SNUPPS

Standardized Nuclear Unit
Power Plant System

September 9, 1981

SLNRC 81-96 FILE: 0541
SUBJ: RSD Review

FIGURE 15.2-15
 NUCLEAR POWER, CORE HEAT FLUX AND
 TOTAL CORE REACTIVITY TRANSIENTS
 FOR MAIN FEEDWATER LINE RUPTURE
 WITH OFFSITE POWER AVAILABLE

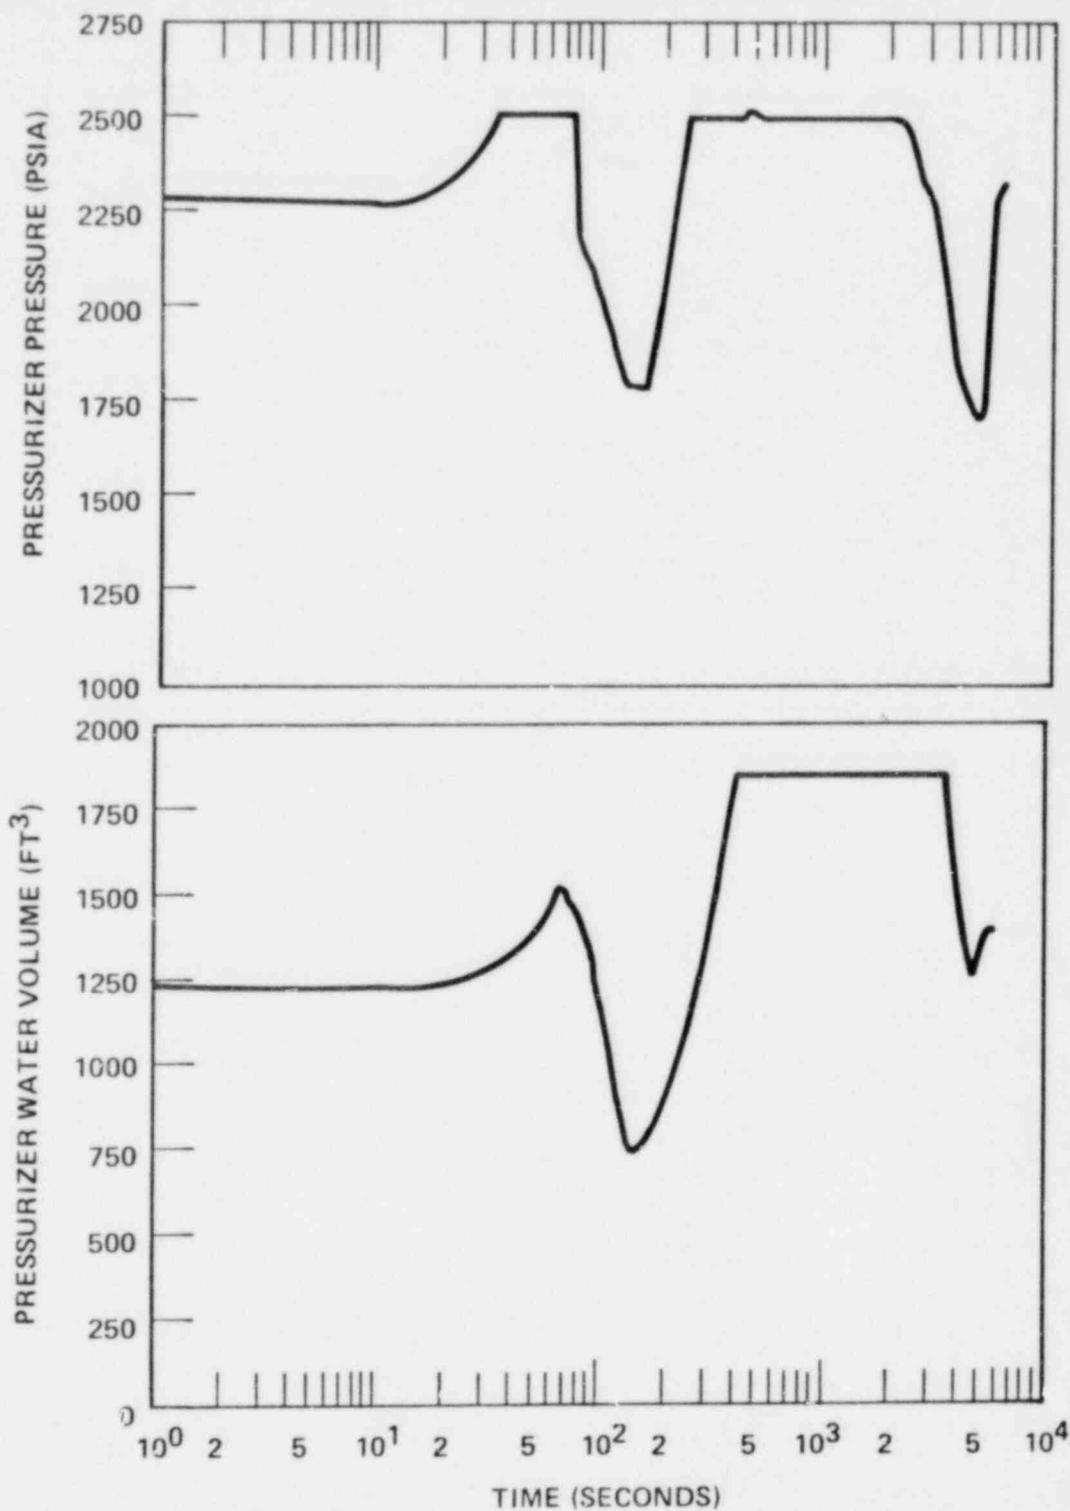
Calculated plant parameters following a major feedwater line rupture are shown in Figures 15.2-15 through 15.2-24. Results for the case with offsite power available are presented in Figures 15.2-15 through 15.2-19. Results for the case where offsite power is lost are presented in Figures 15.2-20 through 15.2-24. The calculated sequence of events for both cases analyzed are listed in Table 15.2-1.

Figures 15.2-15 and 15.2-20 show that following reactor trip the plant remains subcritical.

FIGURE 15.2-16
 PRESSURIZER PRESSURE AND WATER
 VOLUME TRANSIENTS FOR MAIN FEEDWATER
 LINE RUPTURE WITH
 OFFSITE POWER AVAILABLE

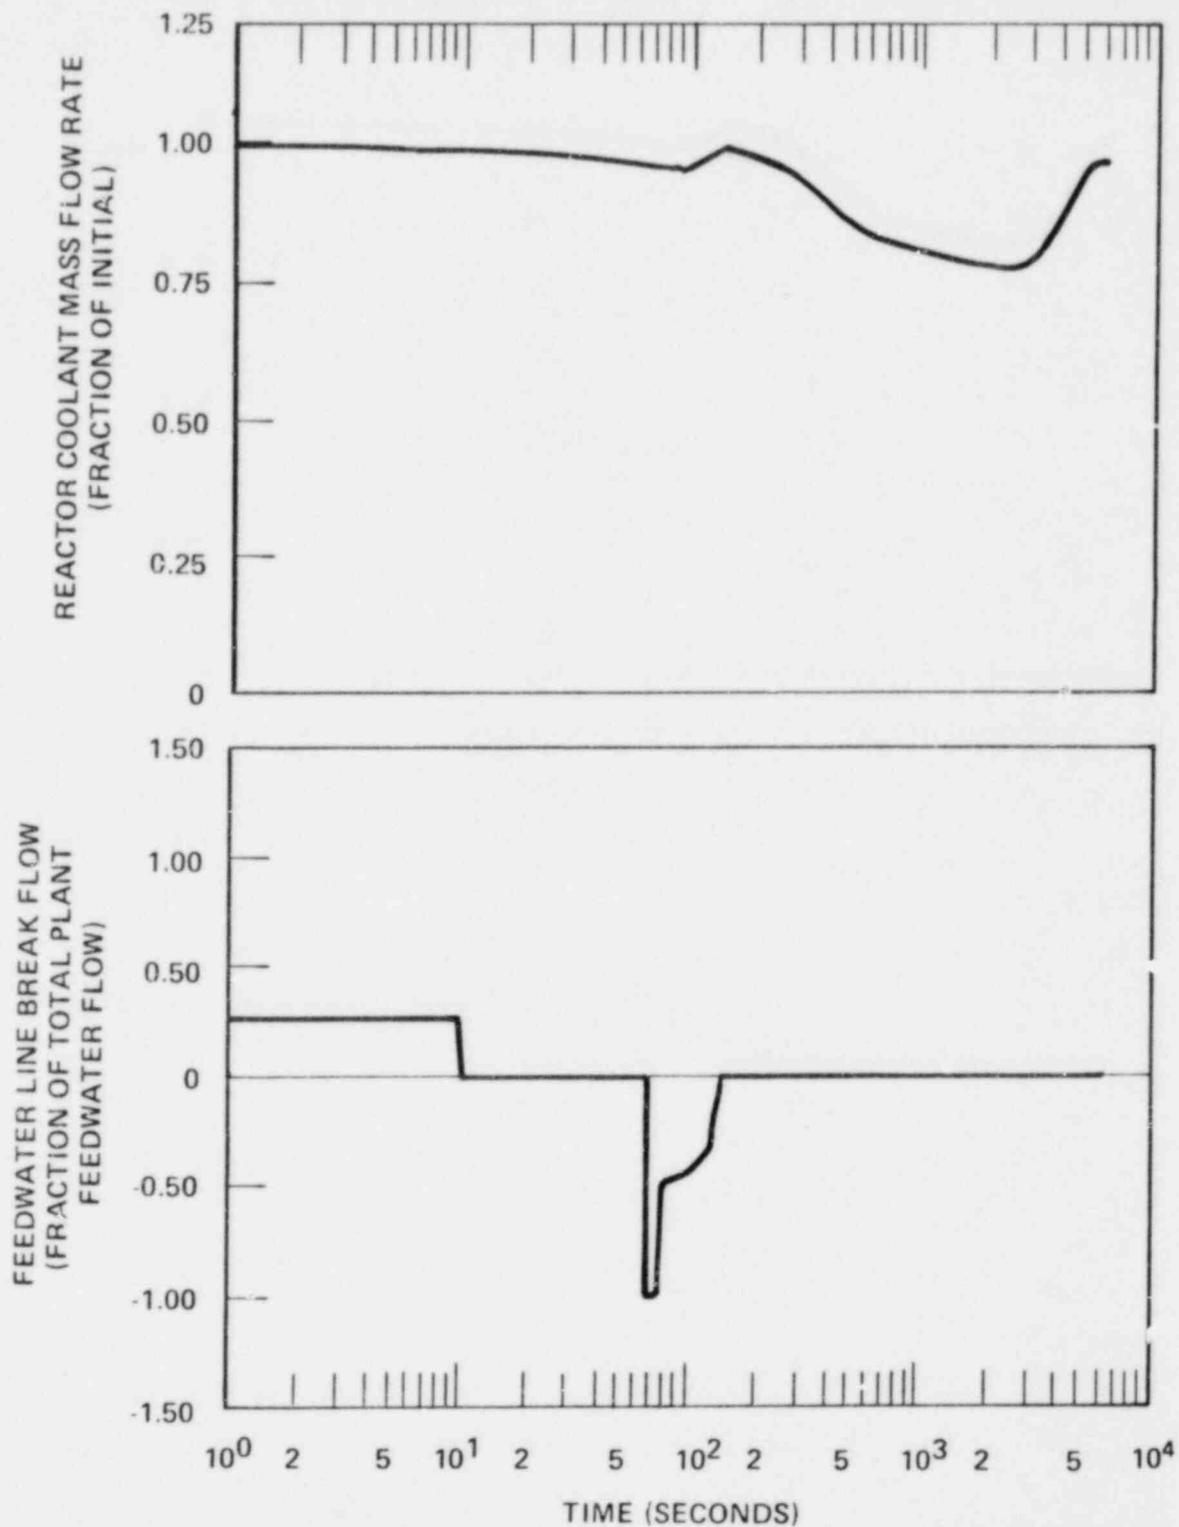
The system response following the feedwater line rupture is similar for both cases analyzed. Results presented in Figures 15.2-16 and 15.2-17 (with offsite power available) and Figures 15.2-21 and 15.2-22 (without offsite power) show that pressures in the RCS and main steam system remain below 110 percent of the respective design pressures. Pressurizer pressure decreases after reactor trip on low-low steam generator level (67.3 seconds). Pressurizer pressure decreases due to the loss of heat input, until the safety injection system is actuated on low steam line pressure in the ruptured loop. Coolant expansion occurs due to reduced heat transfer capability in the steam generators; the pressurizer safety valves open to maintain primary coolant system pressure at an acceptable value. Addition of the safety injection flow aids in cooling down the primary and helps to ensure that sufficient fluid exists to keep the core covered with water.

Figure 15.2-16 shows that the pressurizer does not empty throughout the transient to that the core remains covered at all times and that no boiling occurs in the reactor coolant loops.

FIGURE 15.2-18
 REACTOR COOLANT TEMPERATURE
 TRANSIENT FOR MAIN FEEDWATER LINE
 RUPTURE WITH OFFSITE POWER AVAILABLE

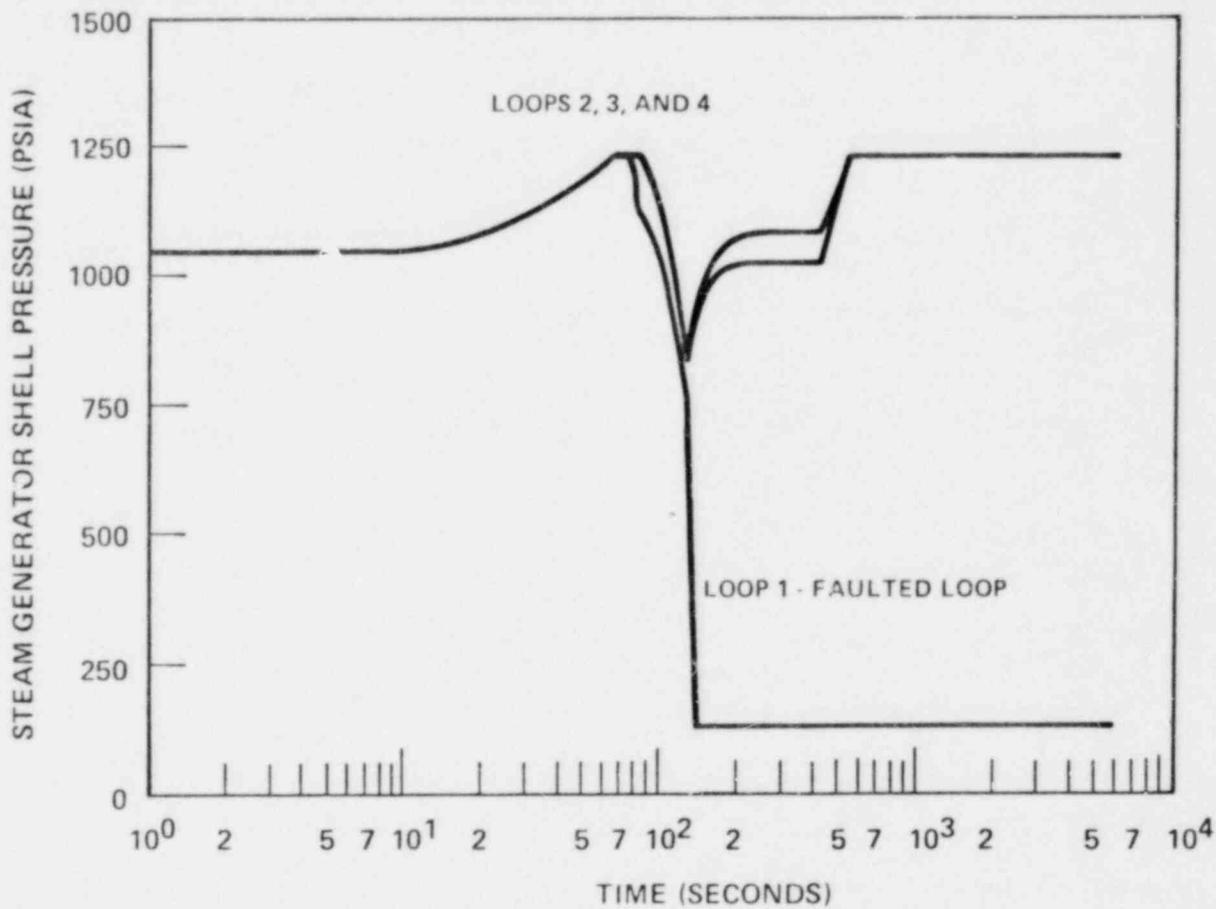
The major difference between the two cases analyzed can be seen in the plots of hot and cold leg temperatures, Figure 15.2-18 (with offsite power available) and Figure 15.2-23 (without offsite power). It is apparent that for the initial transient (~150 seconds), the case without offsite power results in higher temperatures in the hot leg. For longer times, however, the case with offsite power results in a more severe rise in temperature until the auxiliary feedwater system is realigned. The pressurizer fills more rapidly for the case with power due to the increased coolant expansion resulting from the pump heat addition. As previously stated, the core remains covered with water for both cases.
